MANSOURAH - MASSARAH GOLD PROJECT
LAYOUT
EXPLOSIVE MAGAZINE
GENERAL LAYOUT - EXPLOSIVE MAGAZINE

DRAWING NUMBER MD-216-2500-EG-CV-LAD-2001 | REV D01

Mansourah Massarah Gold Project
Comment Resolution Log Sheet / Compliance Report

PROJECT: MANSOURAH MASSARAH GOLD PROJECT **PROJECT NO.:** 216

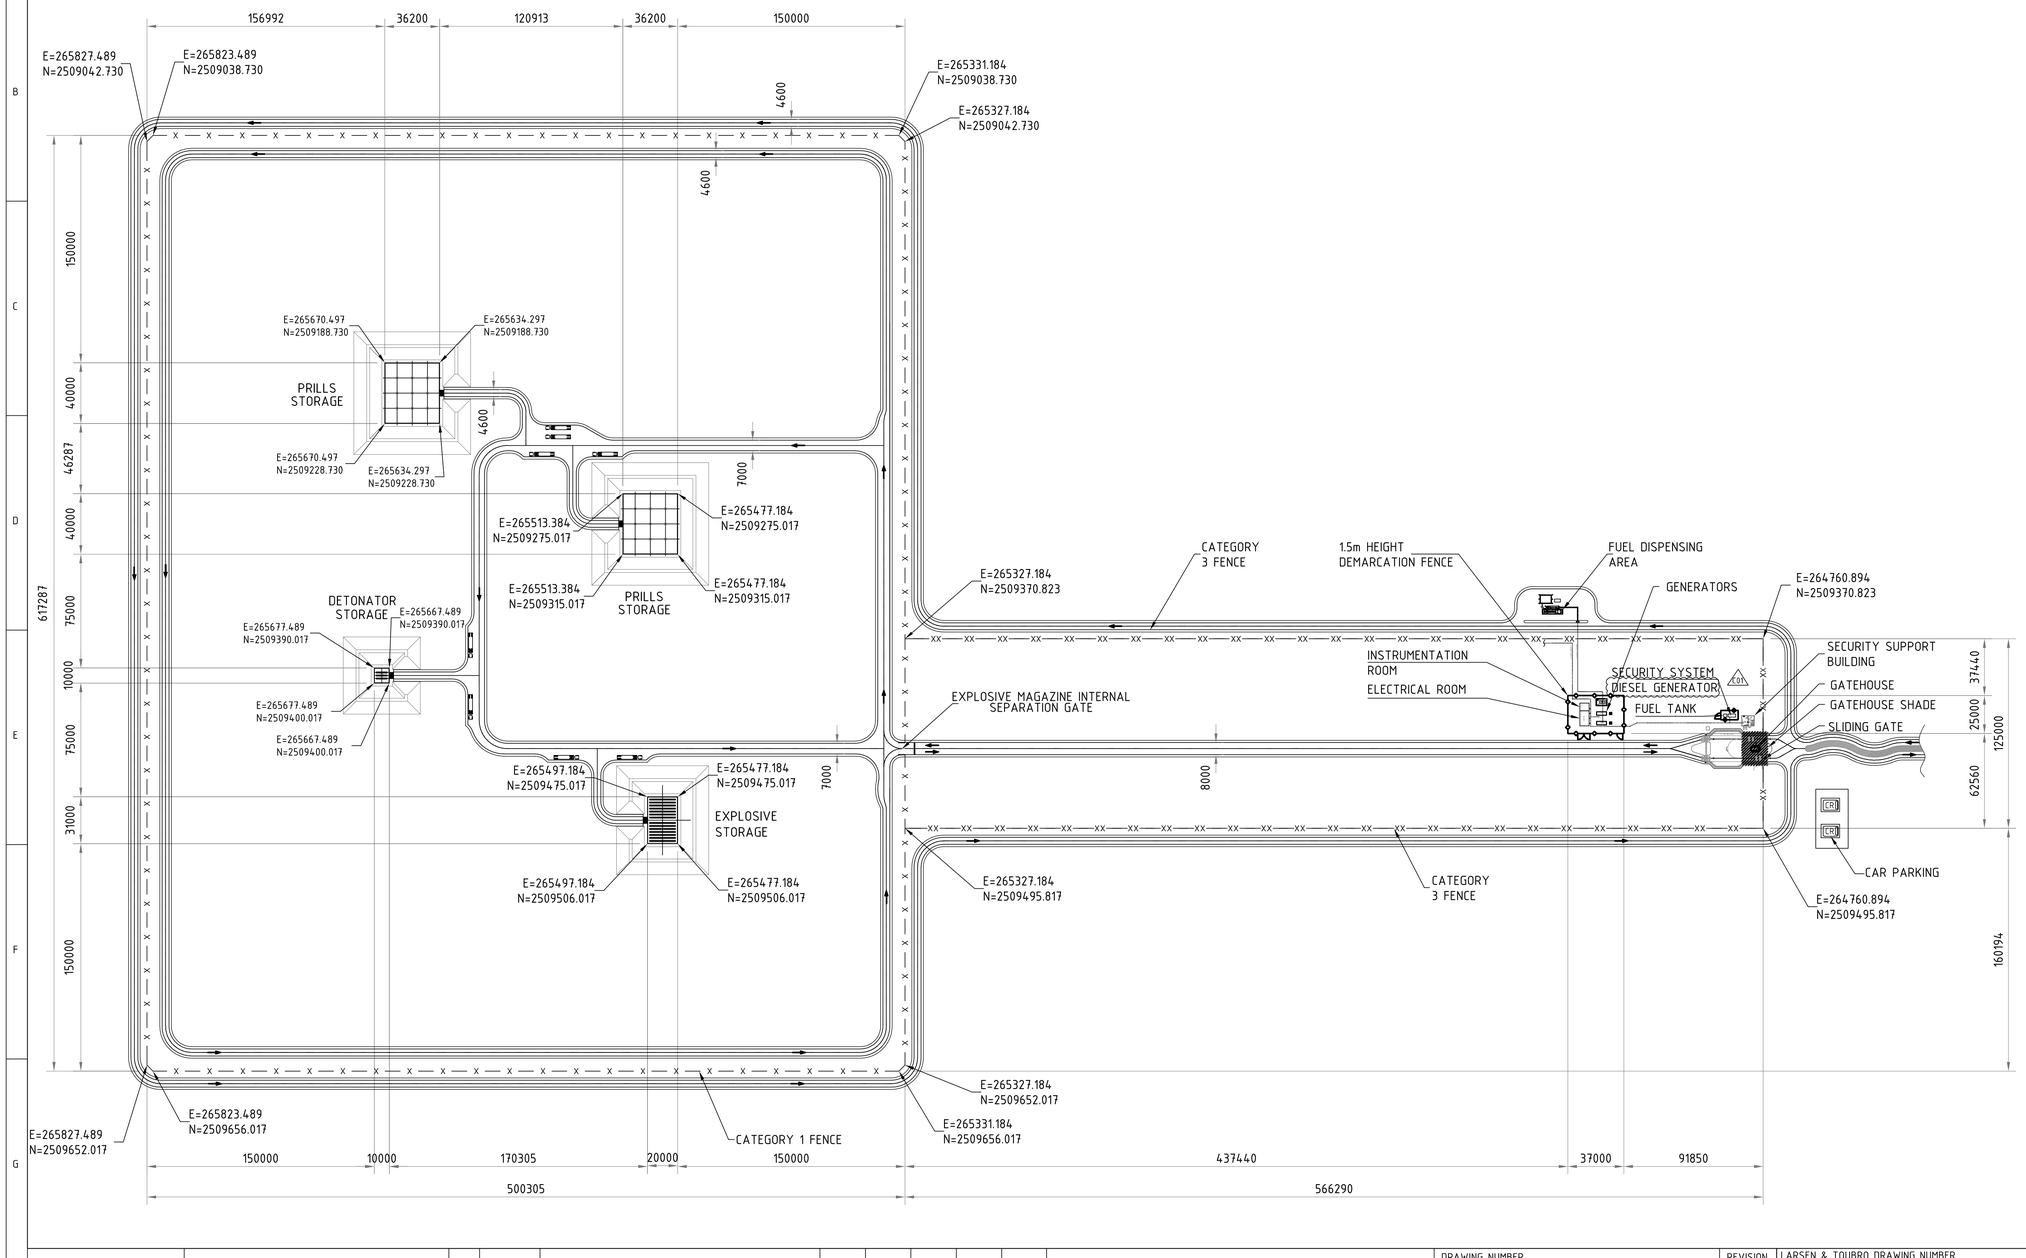
DOCUMENT NUMBER	Area / Title	Comment No.	PMC/PMT COMMENT DATE: 28 October 2020	Comment by	EPC Response DATE: 10 November 2020	Status	Remarks
			General Comments (cc)				
MD-216-2500-EG-CV-LAD-2001-RA02	2500	1	This shall be considered to describe the type of gate: 5.4.11.Locks used on this gate shall be fully compliant with SEC 09. 5.4.12.The gate shall use either a motorised sliding or swing mechanism for deployment	Mr. Doron Golan (BECHTEL)	Explosive Magazine internal separation gate is manually operated according to HCIS approved stage -02 FEED. Please refer to Stage-3 installation details under layout number MD-216-1800-HS-SY-GAD-V516-1625-A02 (Sheet #6) where contains PAD lock detail to comply SEC-9.	Closed	
MD-216-2500-EG-CV-LAD-2001-RA02	2500	2	What security system "DG" means?, use HCIS terminology	Mr. Doron Golan (BECHTEL)	Emergency Power Diesel Generator (DG) is required for security system and devices, Security lighting, Security building HVAC system to comply SEC-7 (5.2).	Closed

DOCUMENT NUMBER	Area / Title	Comment No.	PMC/PMT COMMENT DATE: 11 Auhust 2020	Comment by	EPC Response DATE: 8 October 2020	Status	Remarks
			General Comments (cc)				
MD-216-2500-EG-CV-LAD-2001-A01	2500	1	This drawing nees to be submitted as part of the overall HCIS security package for Approval on Aug 15 2020 as Instructed previously	Mr. Doron Golan (BECHTEL)	Resubmitted for approval as advised by employer	Closed
